Re: **Joliet Junior College, Illinois Community College District No. 525
Master Facilities Plan Phase 1, Campus Center Building Work, Bid Release 12
1215 Houbolt Road, Joliet, Illinois 60431**

Subject: **Supplement No. 2**

LEGATARCHITECTS WAUKEGAN OAK BROOK CHICAGO CRYSTAL LAKE 651 W. WASHINGTON BLVD. - SUITE 1 CHICAGO, ILLINOIS 60661 PHONE: (312) 258-9595 FAX: (312) 258-1555	Joliet Junior College Campus Center	PROJECT NUMBER: 208069	SKETCH ASK-27
	Partial Level 2 - Module 2 Reflected Ceiling Plan	DATE: 01/07/10 REF: Reference: 1/A7.22

Joliet Junior College		PROJECT NUMBER: 208069
Campus Center		
Partial Level 2 Module 2 Reflected Ceiling Plan		
		DATE: 01/7/10
		Ref. Sheets: A5.02 & A7.22

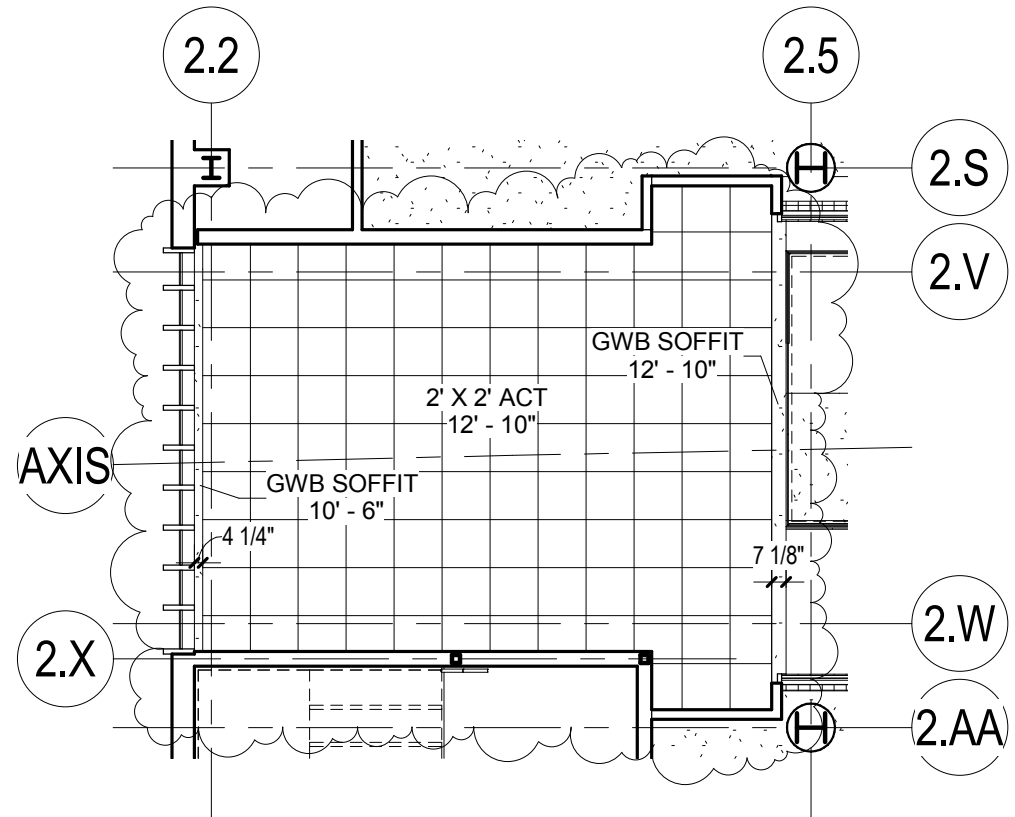
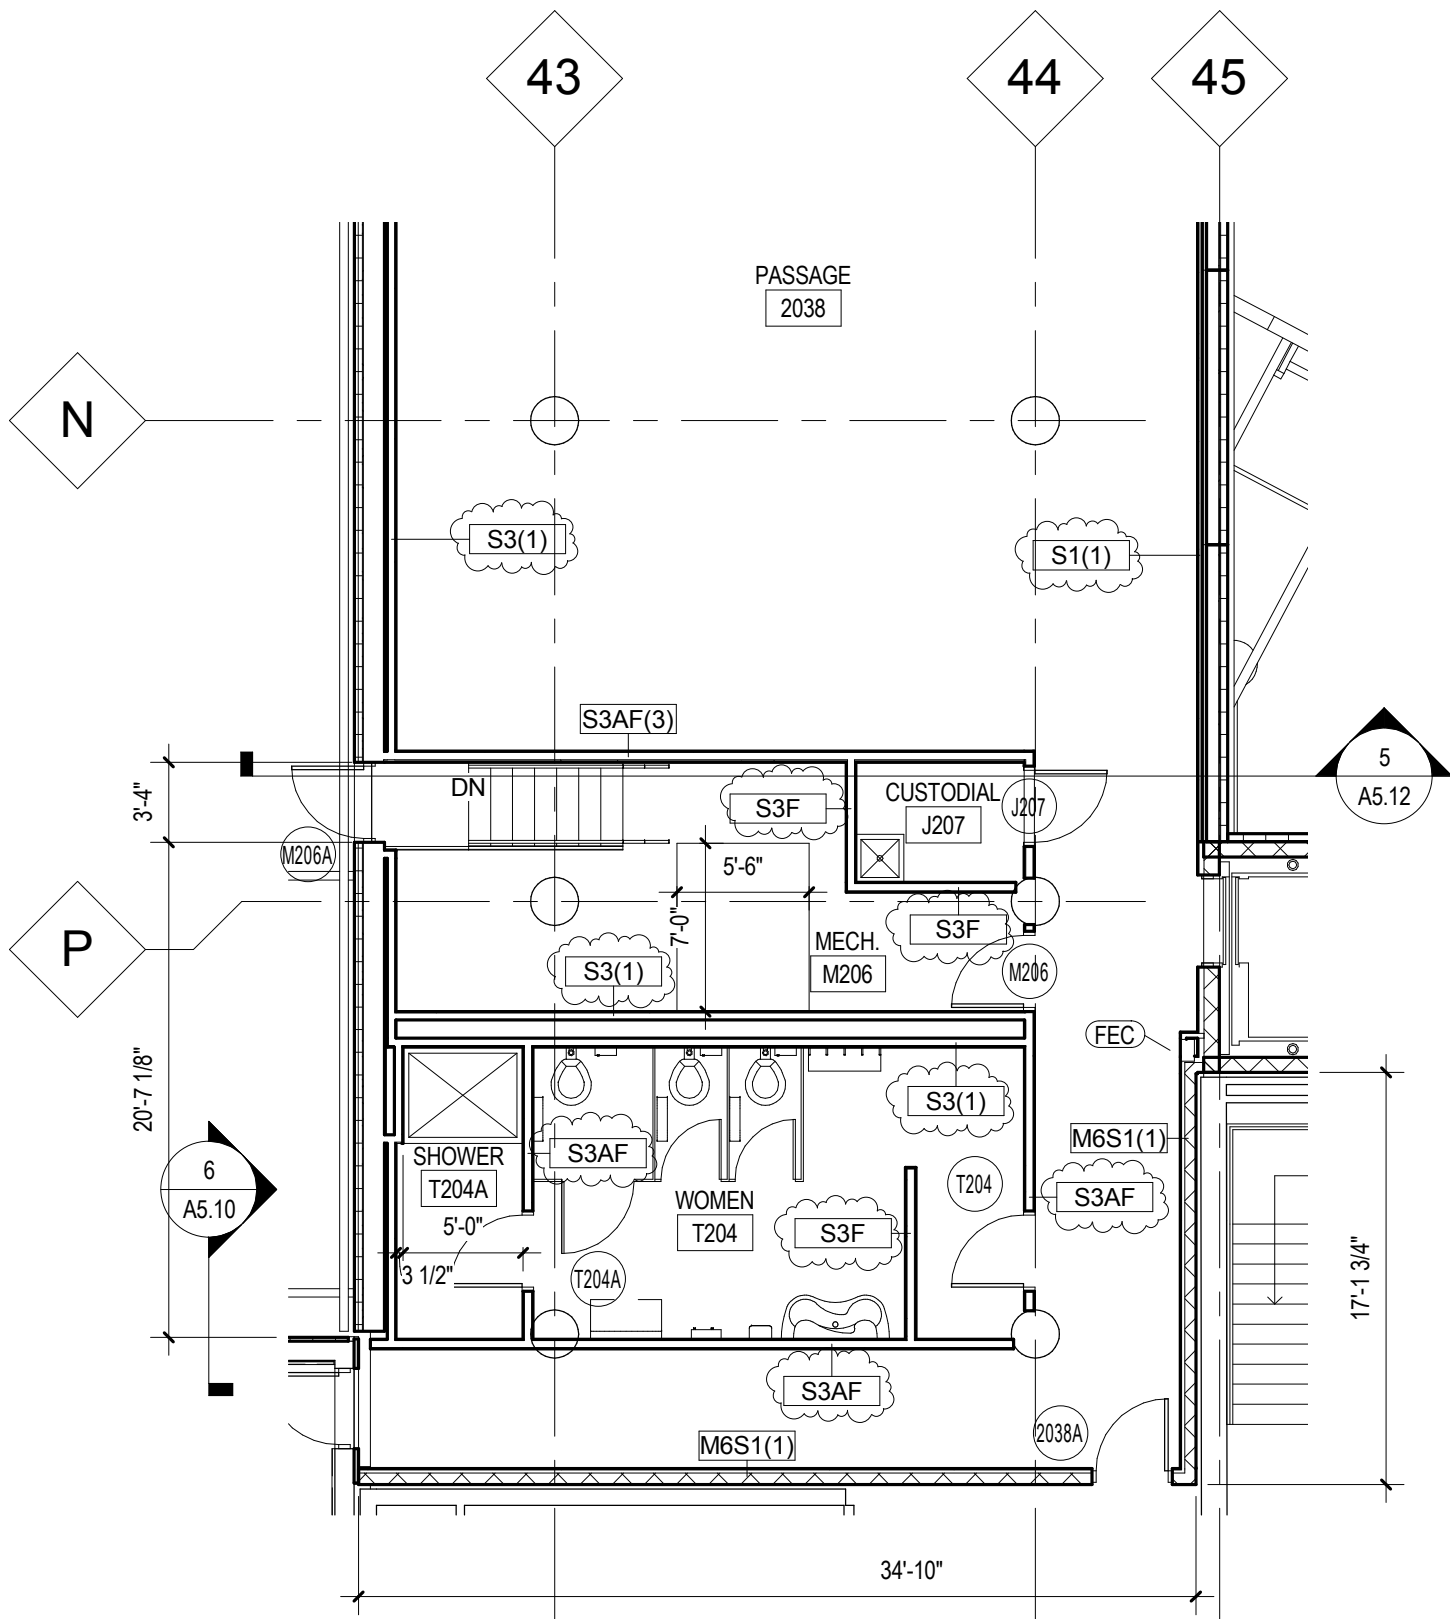
- l) Drawing A4.10:
 i) Detail 1: REVISE “Glass Type FG-5” note between centerlines 2.11 and 2.12 to read, “Glass Type FG-11 with acid etched finish.”
- m) Drawing A5.02: REVISE detail 2 as shown on attached sketch ASK-38.

- cc) Drawing A7.22: REVISE the ceiling plans as shown on attached sketch ASK-38.
- dd) Drawing A7.40:
 i) REVISE Keynote 05500.U2 to read, "Stainless Steel Suspension System."
 ii) ADD the following note:
 "Stainless Steel Suspension System: Basis of design is Sadev Architectural Glass Systems. Components include Model #08-81-80-06-24-20 shelf fixing plate, with Model #08-85-80 tie rods, and

LEGATARCHITECTS WAUKEGAN OAK BROOK CHICAGO CRYSTAL LAKE 651 W. WASHINGTON BLVD. - SUITE 1 CHICAGO, ILLINOIS 60661 PHONE: (312) 258-9595 FAX: (312) 258-1555	Joliet Junior College Campus Center	PROJECT NUMBER: 208069 DATE: 01/7/10	SKETCH
	Partial Level 2 Module 1 Floor Plan	ASK-39

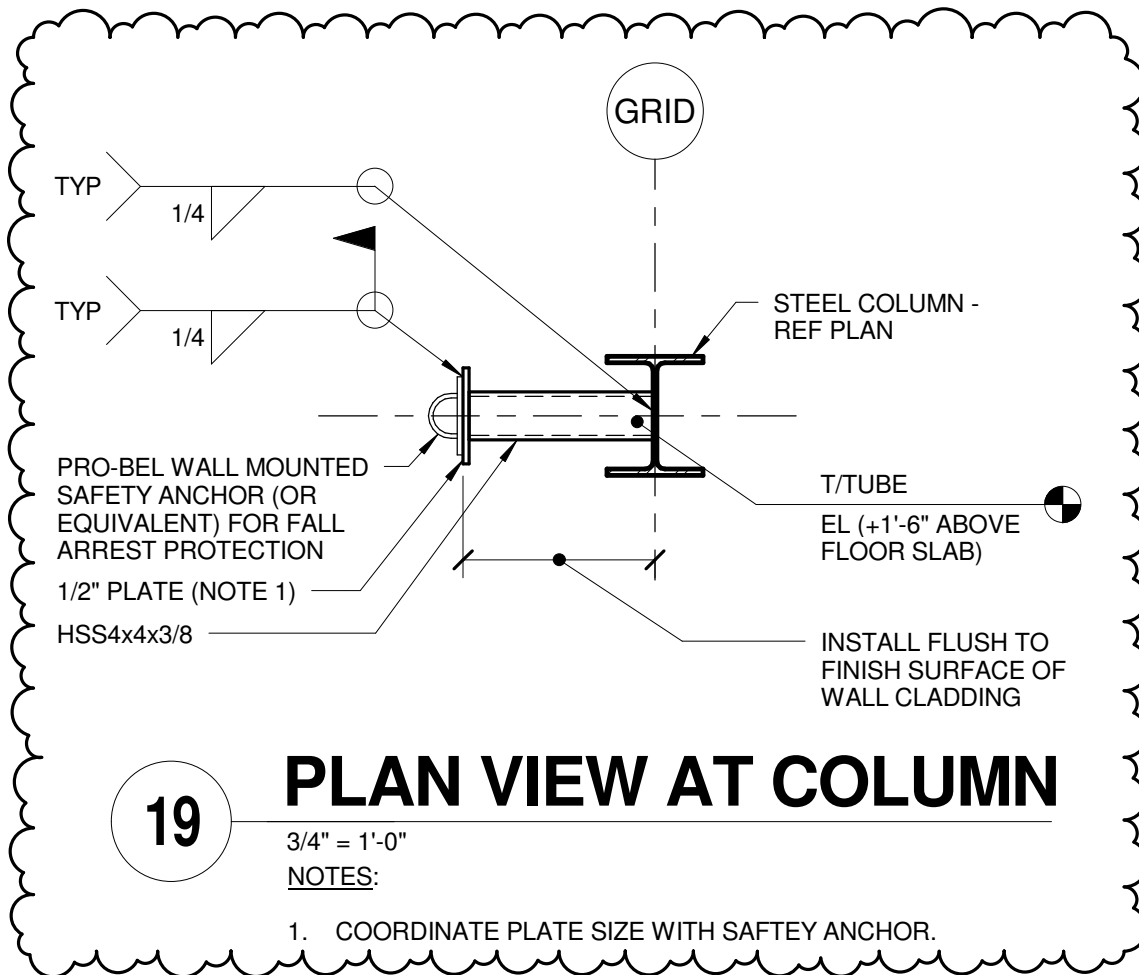
- g) Drawing A1.21: ADD partition types as shown on attached sketch ASK-39.
- h) Drawing A2.11:
 - i) Doors 2017, 3032A, and 3061A: ADD frame type "HM."
 - ii) Door 3046A: REVISE height to be 94" high.
